Stepaside Improvement Scheme - Phase 1

Public Consultation Report

210182-X-X-XXX-RP-DBFL-CE-0002

February 2024

Figure 4-3: Typical Scheme Cross Section

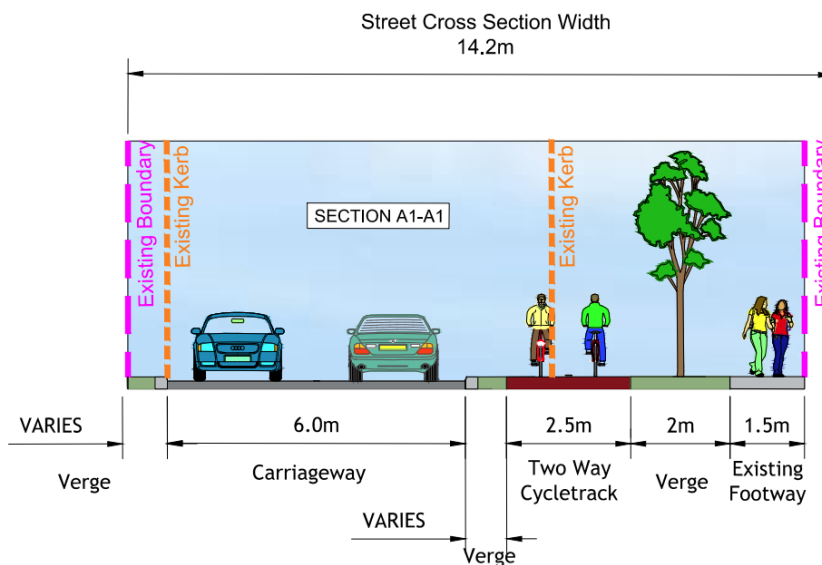
General Comment 2: Some submissions indicated that the proposed vehicle lane widths of 3 metres are too narrow and cause congestion.

Response to General Comment 2: With regard to the reduction in road width, the road carriageway has been designed to the DMURS design guidance of 3m which is appropriate for a 50 km/h street such as the Enniskerry Road. The reduction in carriageway width will contribute to traffic calming throughout the area, slowing vehicles. This allows for two buses to pass one another in a slower traffic environment as well as emergency service vehicles to pass traffic.

Figure 4-4: Subject Scheme - In the Vicinity of Stepside Park

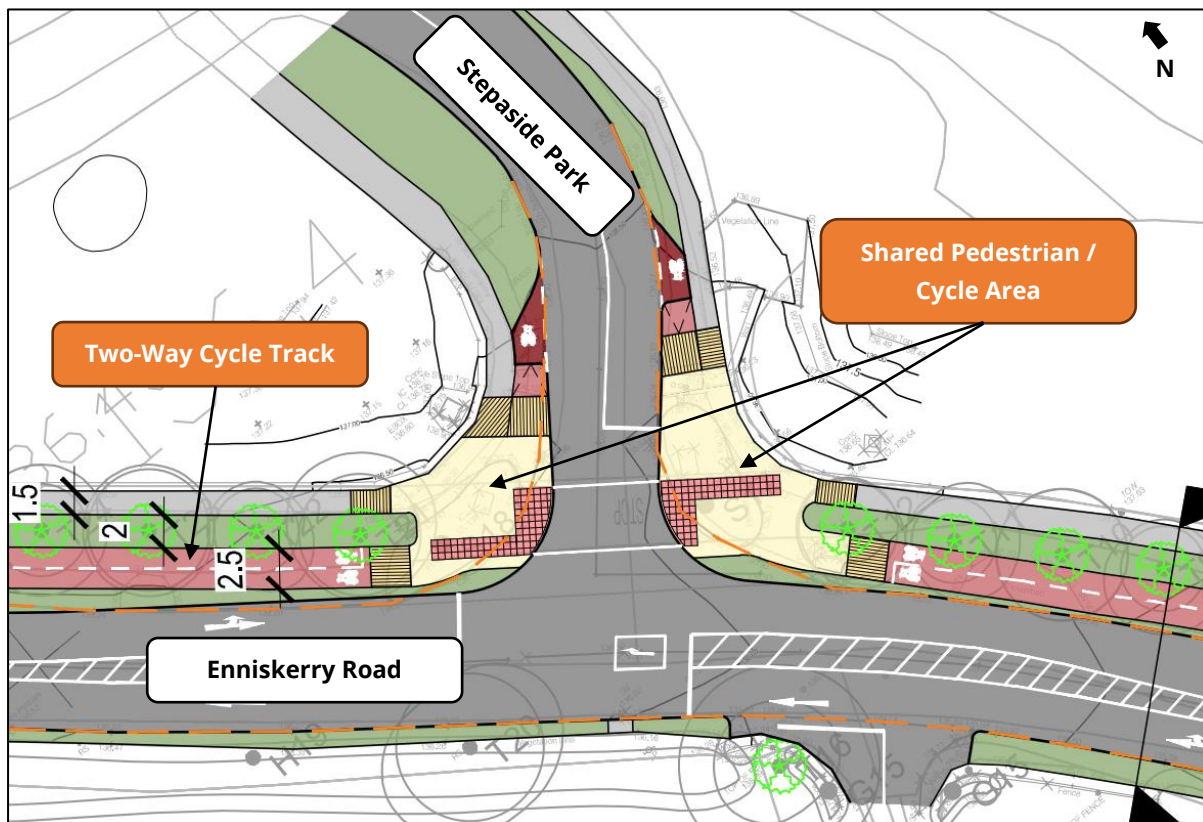
General Comment 1: A number of submissions questioned the proposed signalisation of Stepside Park Junction, citing the success of the roundabout at Belarmine, and the possible increased congestion from the signalisation. Many submissions also requested for a roundabout to replace the Stepside Park Junction.

General Comment 2: Several submissions highlighted their disagreement with the removal of greenery in the vicinity of the Stepside Park Junction as part of the subject scheme.

Response to General Comment 1: The junction at Stepside Park was chosen to be signalised as this offers a higher level of safety for pedestrians and cyclists using the junction. Additionally, The signalisation of Stepside Park is conditioned under planning reference D13A/0190 and ABP PL06D.242585 (Condition 9).

Response to General Comment 2: The current design was chosen due to its minimal effect on the greenery along the length of the scheme. The proposed two-way cycle track does not require the removal of any trees, just the trimming back of branches and removal of a small area of planting at the Stepside Park Junction. The landscaping and public realm at Stepside Park will be further developed at Detailed Design. A small area of hedgerow is to be removed adjacent to St Patrick's Park, which has been deemed by DLRCC's Parks Department as acceptable. Mitigation measures will be further developed at detailed design.
